City of East Bethel
Planning Commission Agenda
Planning Commission Regular Meeting
Date: September 23, 2025

Request: PUBLIC HEARING. Consider a Site Plan and Conditional Use Permit (CUP) for Atlas Villas Memory Care located east of Ulysses St. and north of 185th Ave. NE (PIN #32-33-23-24-0015 and #32-33-23-24-0016) (City file 25-023).

On August 21, 2025, staff received an application from Stone Construction for a Site Plan Review, CUP, and Easement Vacation to allow the construction and operation of Atlas Villas Memory Care at PIN #32-33-23-24-0015 and #32-33-23-24-0016. The vacation is reviewed only by the City Council.

CIVIL SITE PLAN
ATLAS MEMORY CARE

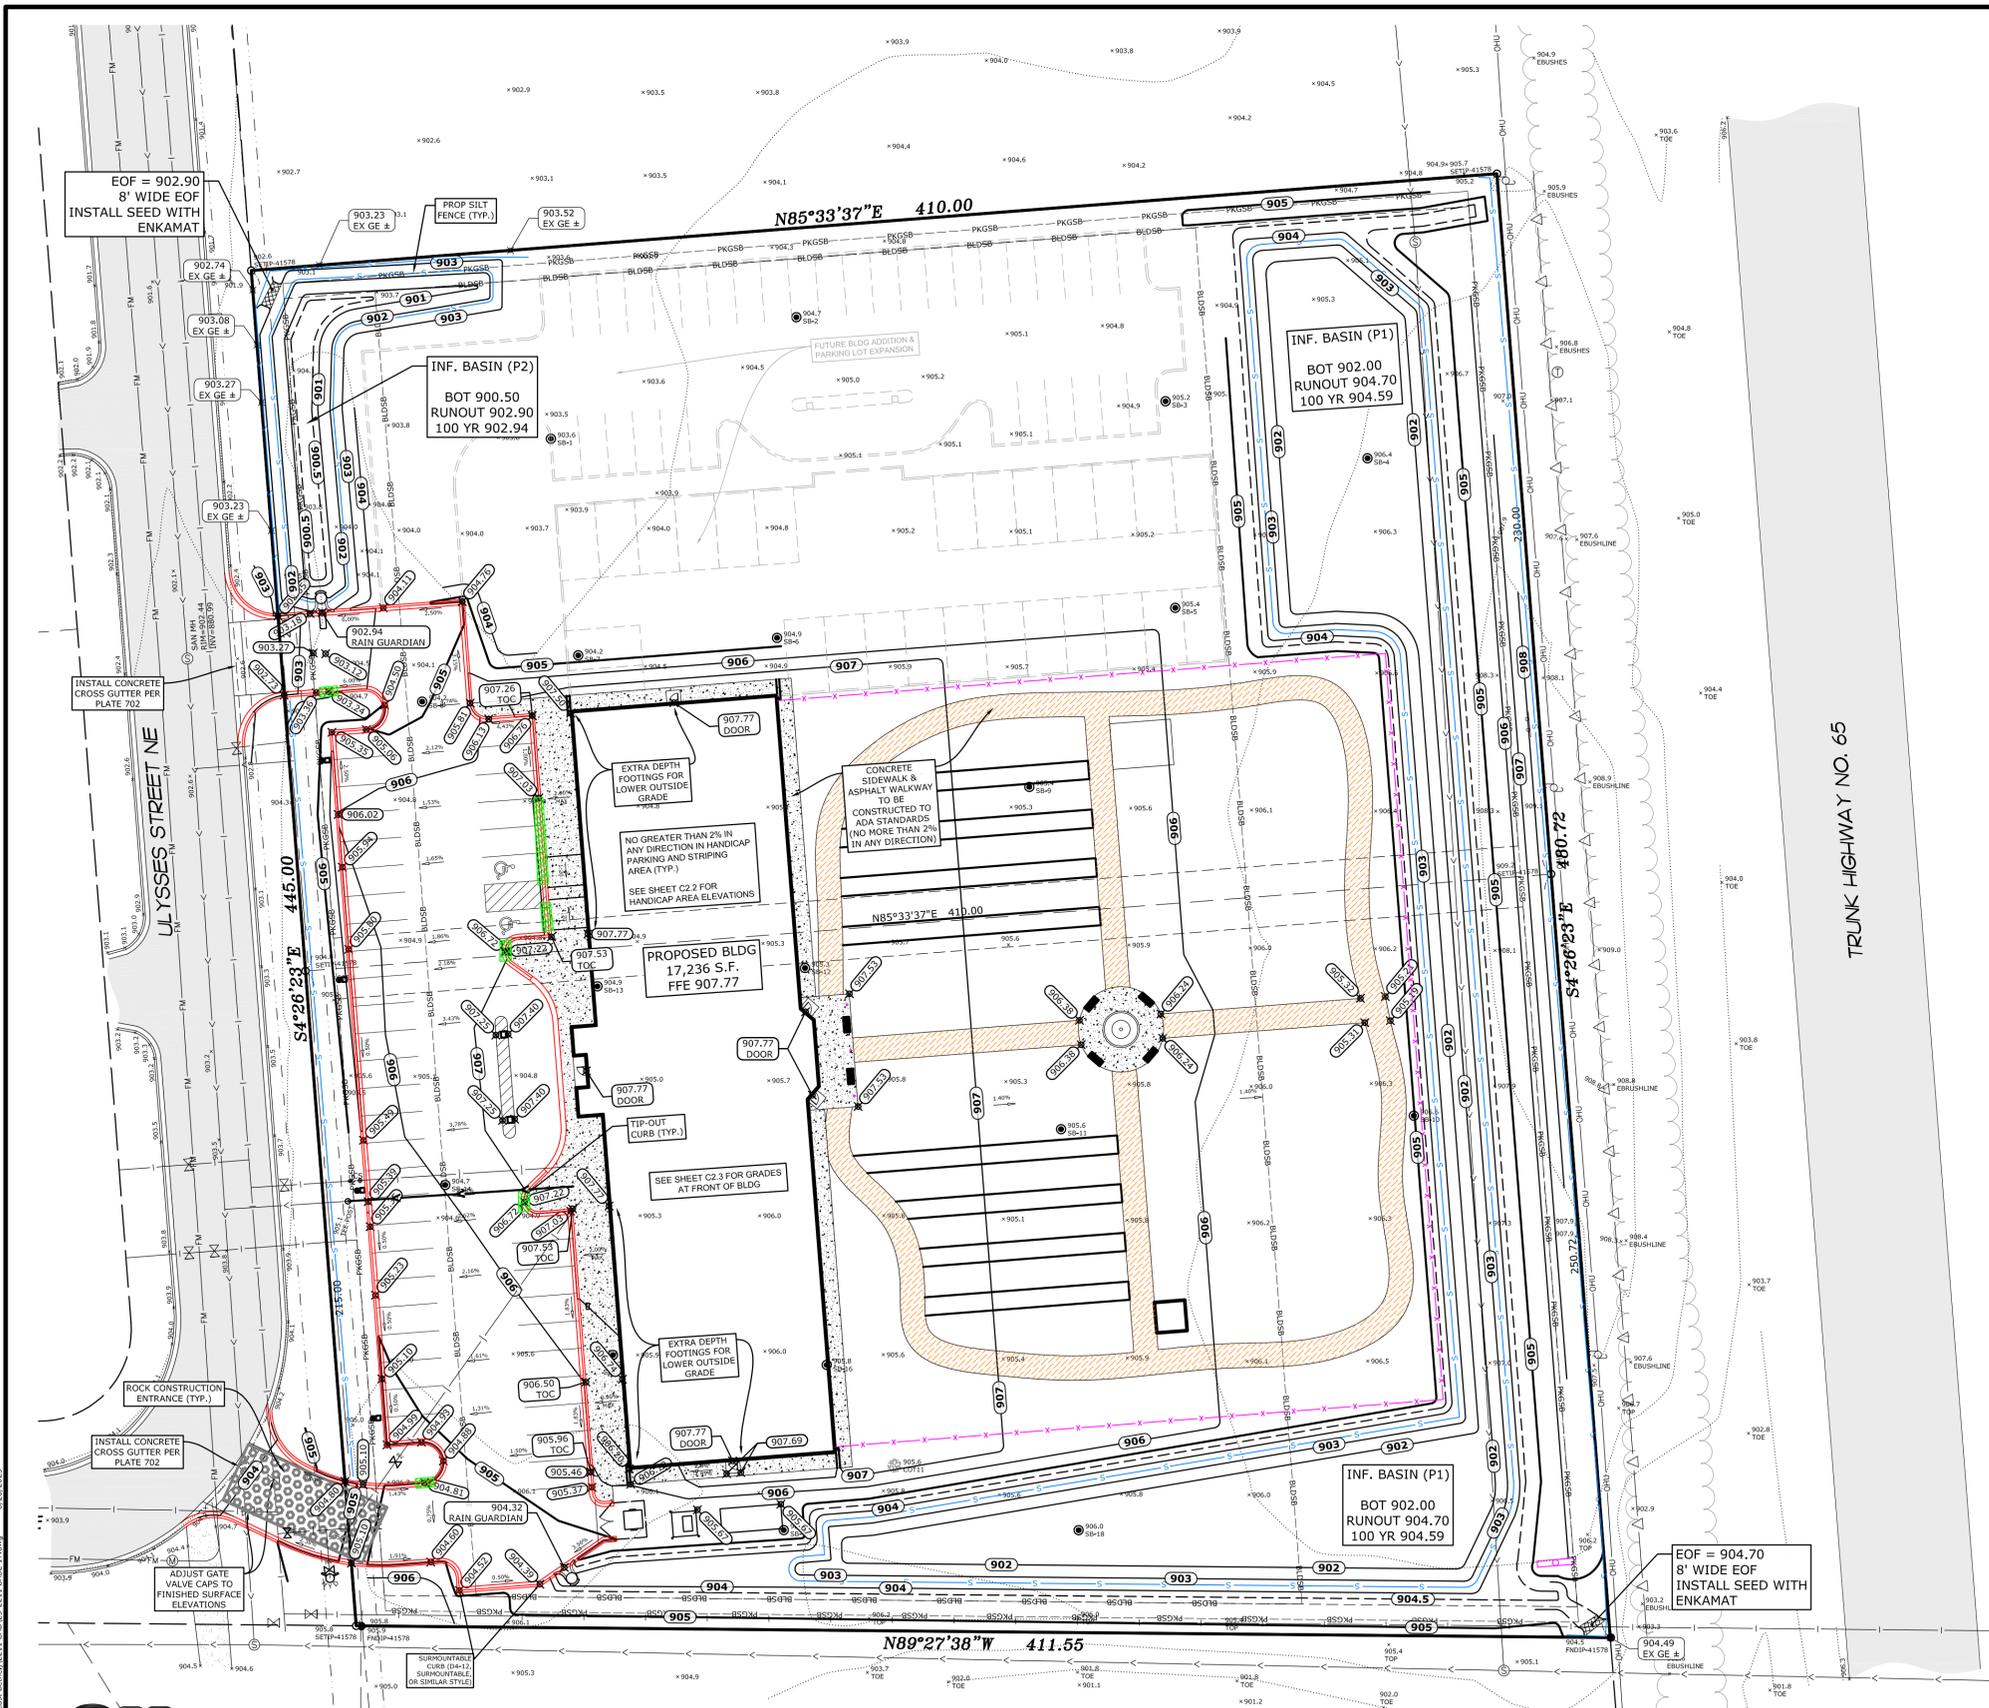
This site will have two access points from Ulysses Street which is allowed in the B-3 Zoning District. The City Engineer’s comments note that Ulysses Street is expected to extend south in the future with a T intersection at 185th Avenue. At that time, the property owner will be responsible for all costs associated with reconstructing the south driveway access. The City Engineer’s comments also note that the applicant will need to revise the current plans to show that the south driveway access will not interfere with a gravel drive used to access the vacant lot to the south. Compliance with the City Engineer’s comments has been added as a condition of approval.

8. The plans must be revised to show that the south driveway access does not interfere with the gravel drive extending south from Ulysses Street.
9. If Ulysses Street is extended south at any point in the future, the property owner will be responsible for all costs associated with the removal and reconstruction of the south driveway and other site features.

GRADING, DRAINAGE, AND EROSION CONTROL PLAN ATLAS MEMORY CARE

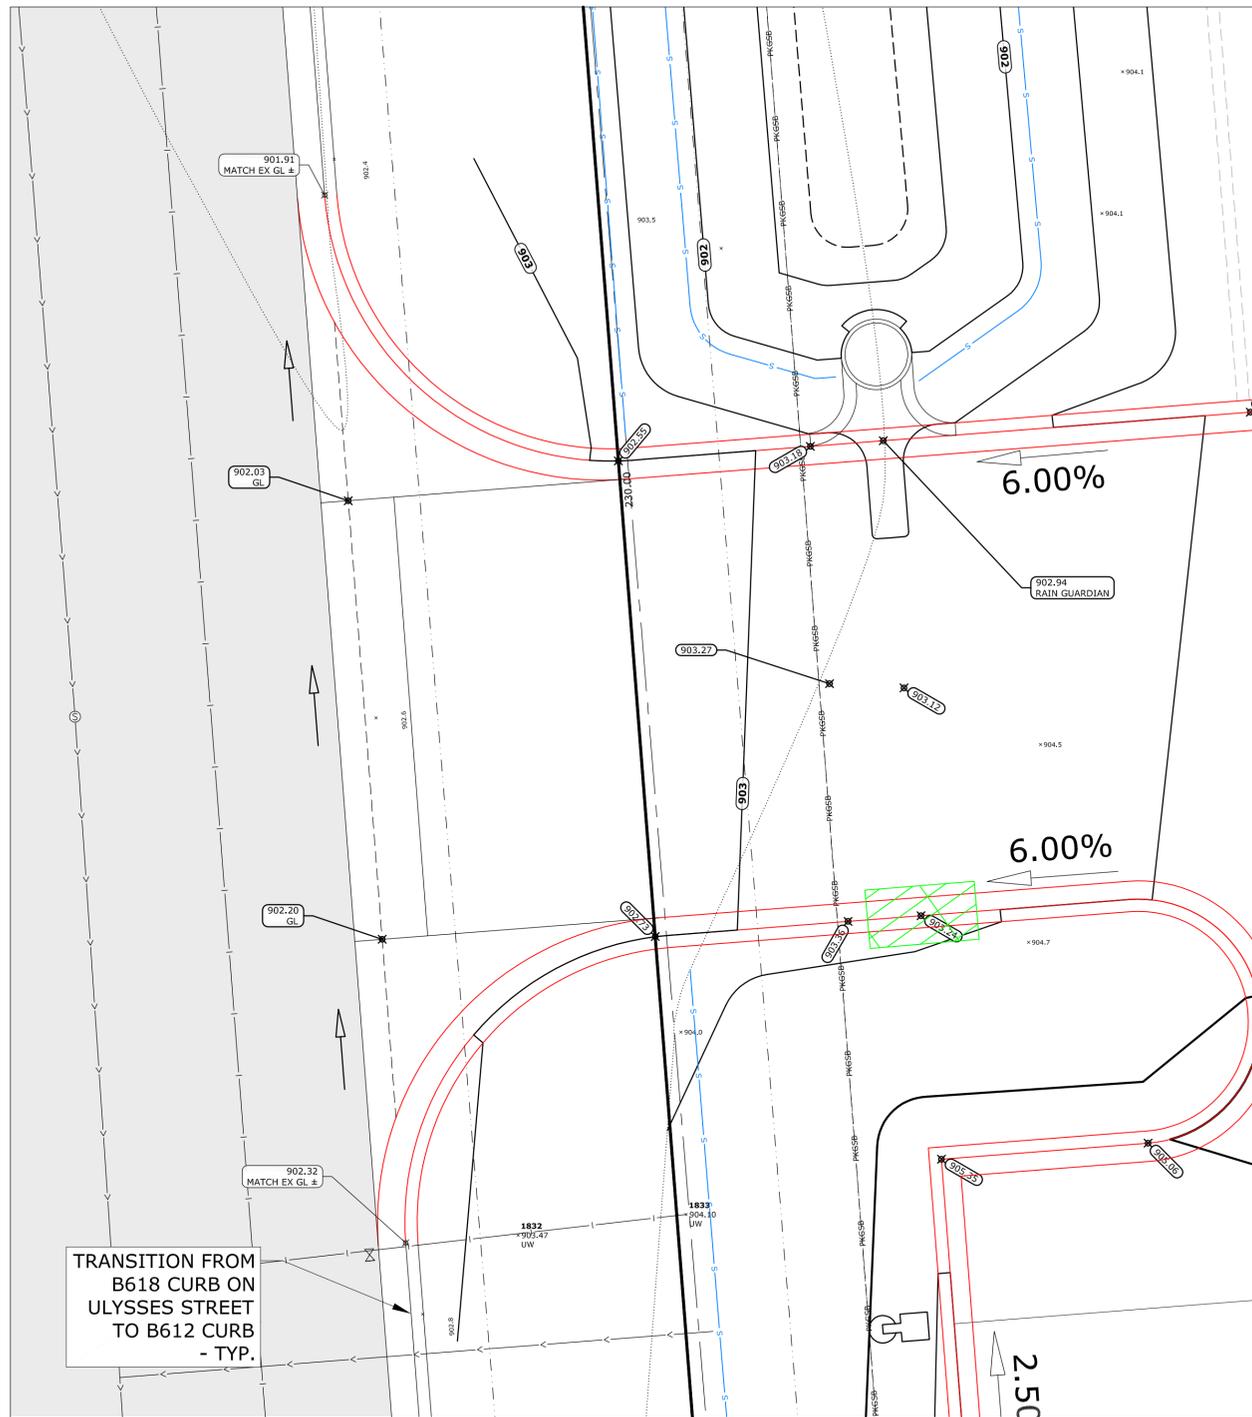
15. Sheet C2.1 mentions 3:1 slopes in a note. All slopes shall be 4:1 or flatter. Also, it is not clear where silt fence is proposed.
16. The note on Sheet C3 indicates the watermain will be 4-inch, but a 6-inch service is shown. All new service shutoff valves need to be installed within City easements or right-of-way.
